Sewerage & Water Board OF NEW ORLEANS

Addendum No. 7

Your reference is directed to **Contract Number:** 2023-SWB-97 (Contract 1420) for WPC Phase 1 Equipment Installation which is scheduled to open at **11:30 a.m. CST on February 23, 2024** for SWBNO Civil Engineering Department.

BALANCE OF PLANT AREA OVERALL WALKWAY STEEL PLAN

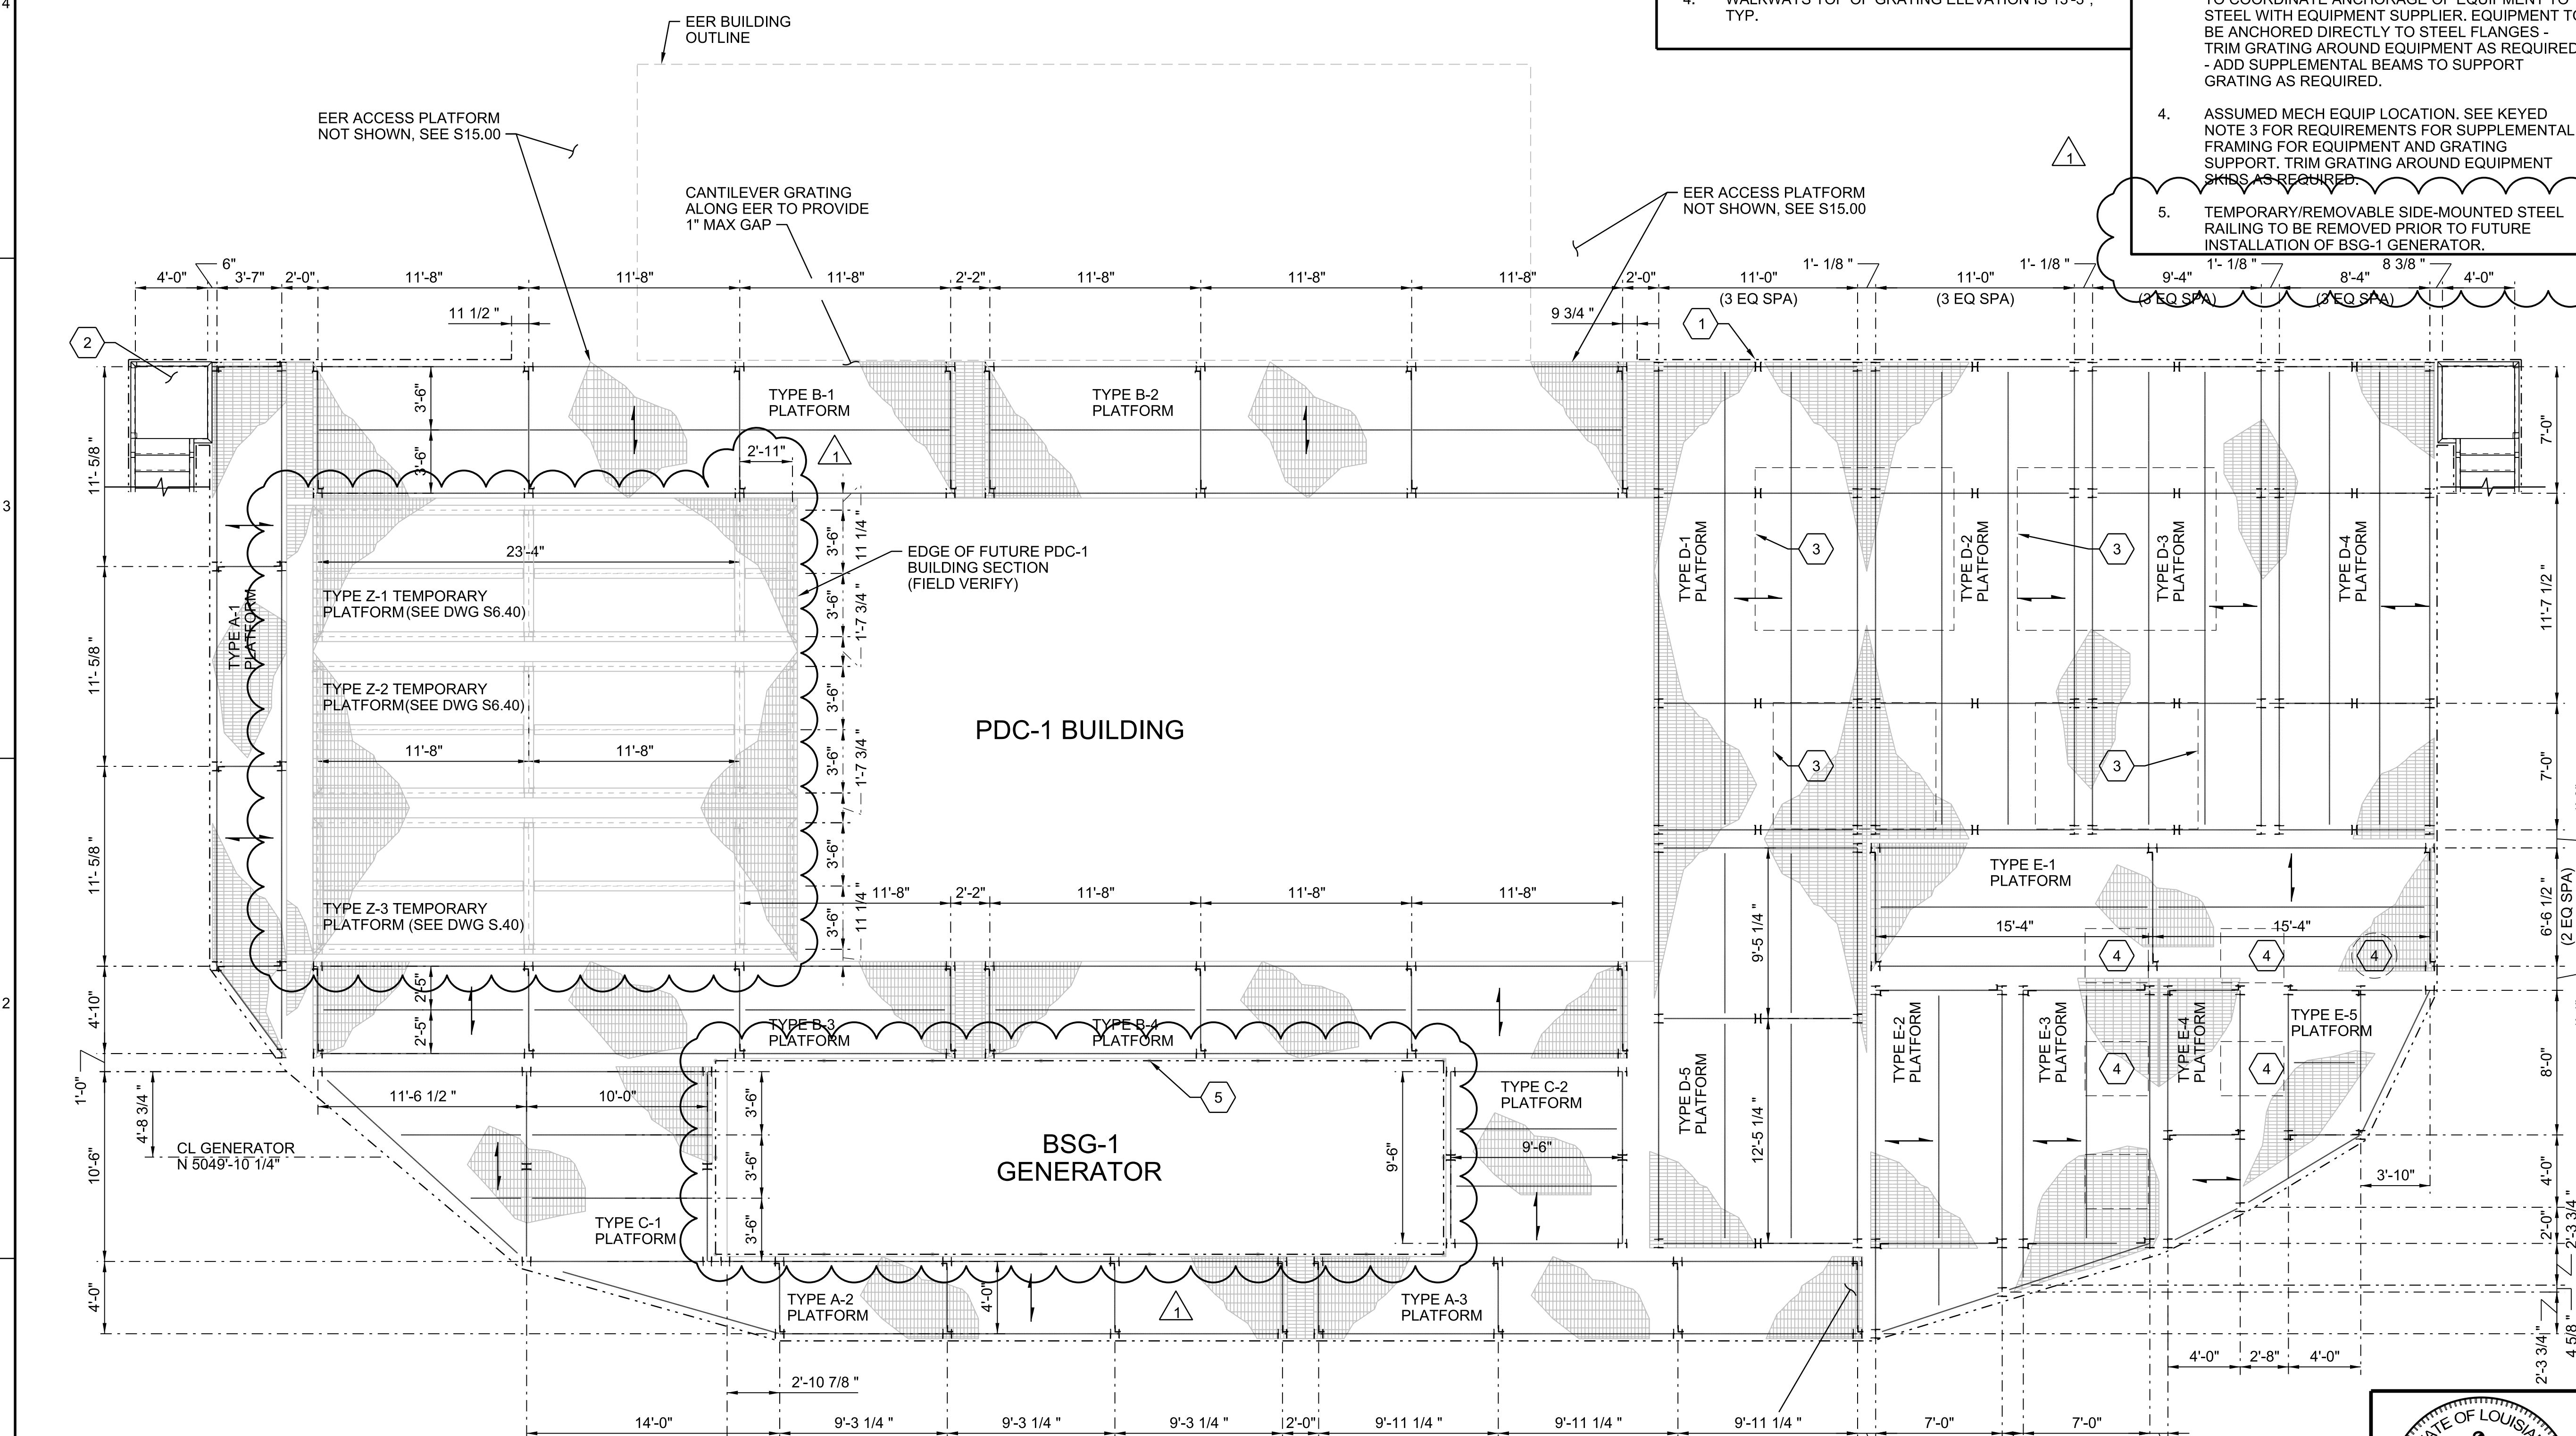
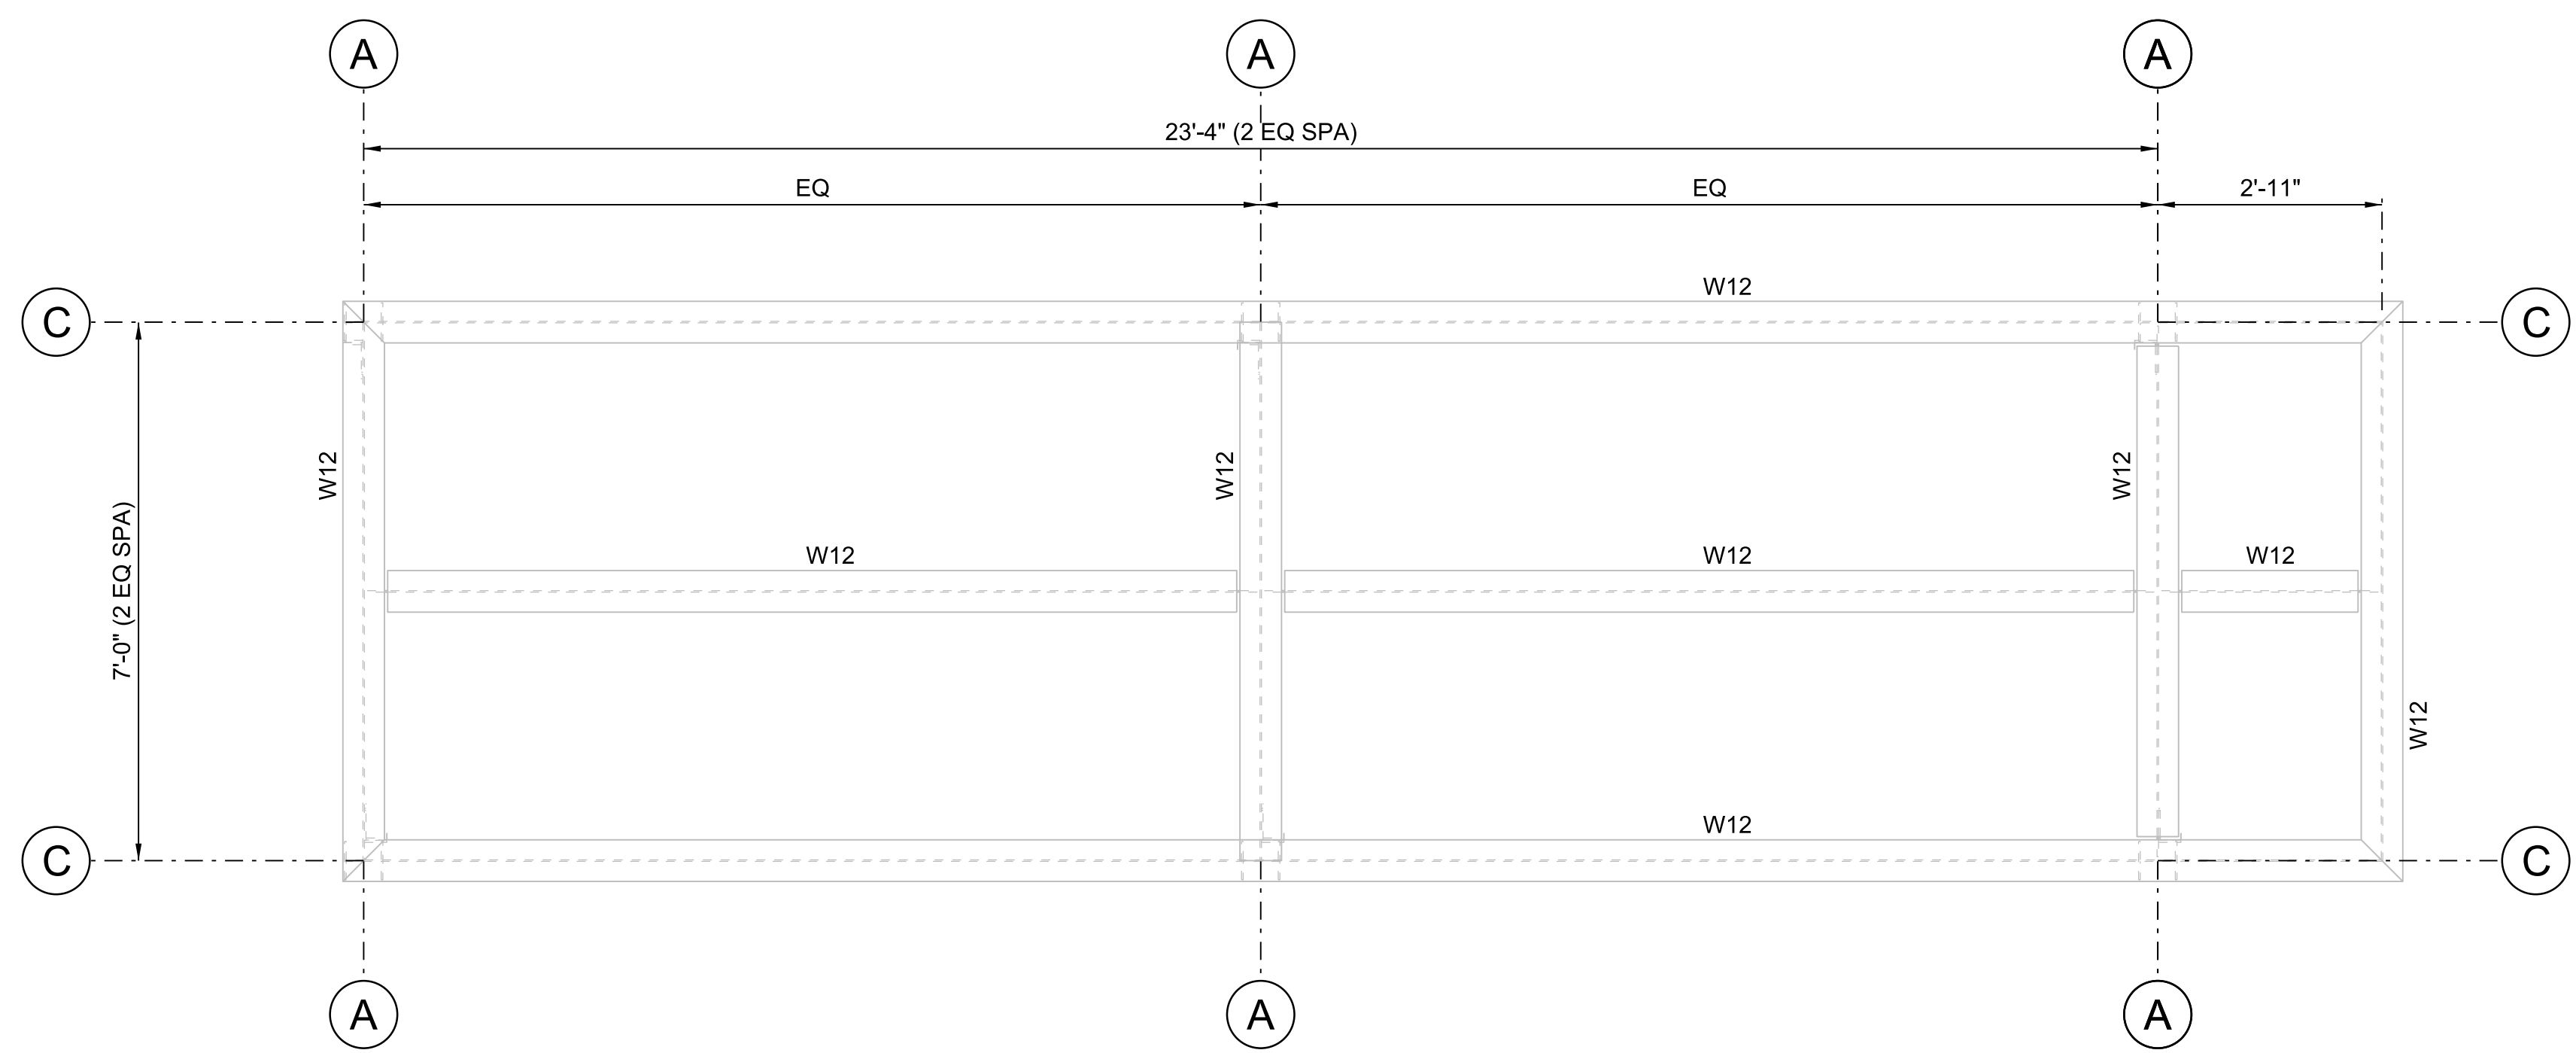
1. Volume 3; REPLACE drawing S6.20 with the attached Revision 1 of the same drawing.
 - a. [Attachment – S6.20_D3483600_r1 \(Page 3\)](#)
2. Volume 3; ADD drawing S6.40, attached.
 - a. [Attachment - S6.40_D3483600_r0 \(Pages 4\)](#)
3. Updated Bid Form – Section 00 41 13
 - a. [Attachment – SWBNO_1420_BidForm_Jan 2024 \(Pages 14-23\)](#)
4. Volume 2, Section 01 11 01, Project Summary of Work, Paragraph 1.03, DELETE the table in its entirety and REPLACE it with the following table.
